## NVM Express Technical Errata

<b>Errata ID</b>	027
<b>Change Date</b>	8/3/2012
<b>Affected Spec Ver.</b>	NVM Express 1.0c
<b>Corrected Spec Ver.</b>

**Figure 23: Round Robin Arbitration**

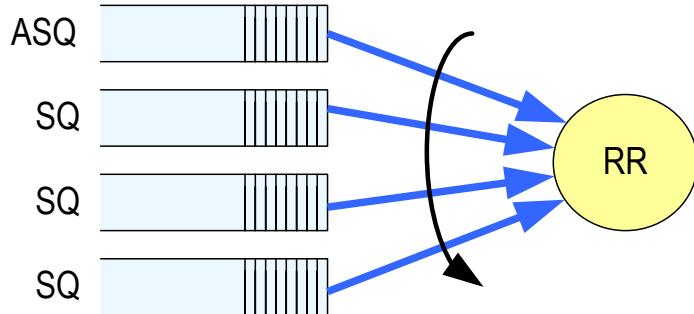
If the round robin arbitration mechanism is selected, the controller shall implement round robin command arbitration amongst all Submission Queues, including the Admin Submission Queue. In this case, all Submission Queues are treated with equal priority. The controller may ~~launch~~ select multiple candidate commands ~~for processing~~ from each Submission Queue per round based on the Arbitration Burst setting.

**Figure 24: Weighted Round Robin with Urgent Priority Class Arbitration**

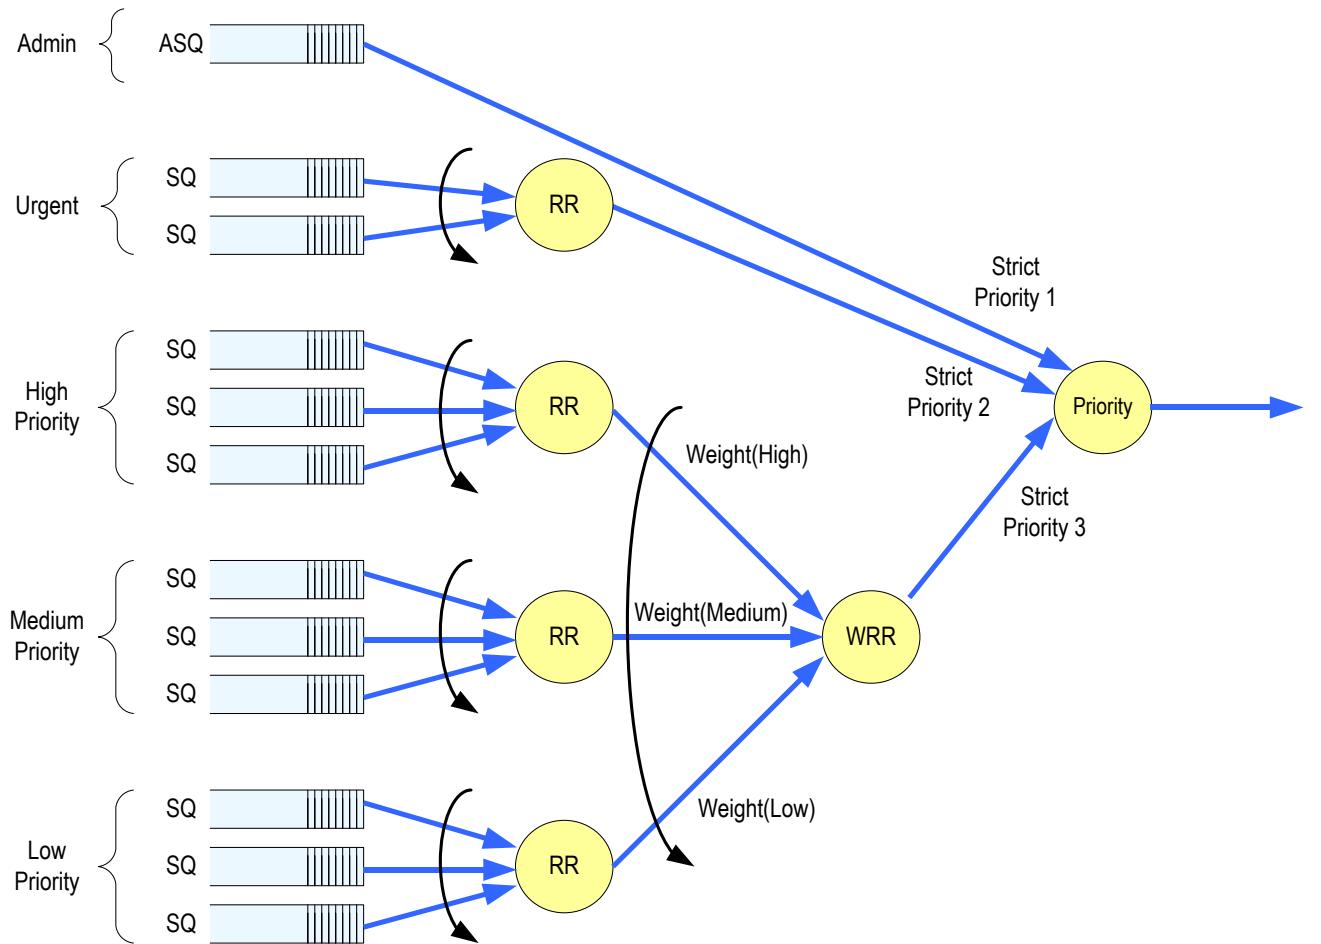
In this arbitration mechanism, there are three strict priority classes and three weighted round robin priority levels. If Submission Queue A is of higher strict priority than Submission Queue B, then all candidate commands ~~that are ready for execution~~ in Submission Queue A shall ~~start processing be launched~~ before candidate commands from Submission Queue B ~~start processing are launched~~.

In Figure 24, the Priority decision point selects the highest priority **candidate command selected next to start processing submitted for execution next**.
